MINI CEILING SYSTEMS
DAMA-XXXX-AO/1.0-2.5 TON
AIR COOLED SPLIT W/DRCU
OUTDOOR CONDENSING UNIT

538-900-072
DWG NO.

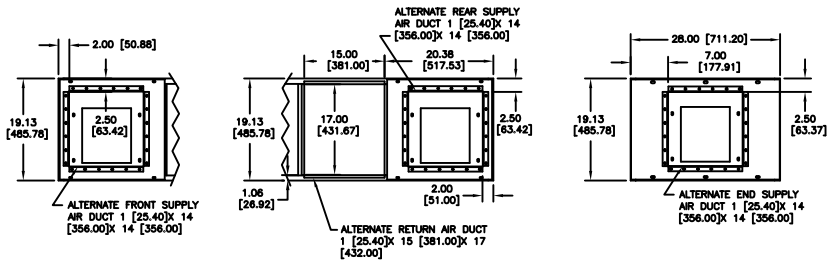
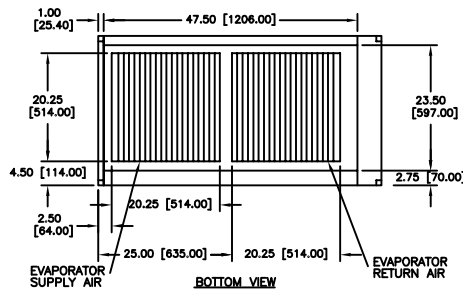
REVISIONS				
REV	DESCRIPTION	DATE	BY	CHKBY
D	DECREASED CONDENSING UNIT HEIGHT 4"	05-15-17	MTC	MP
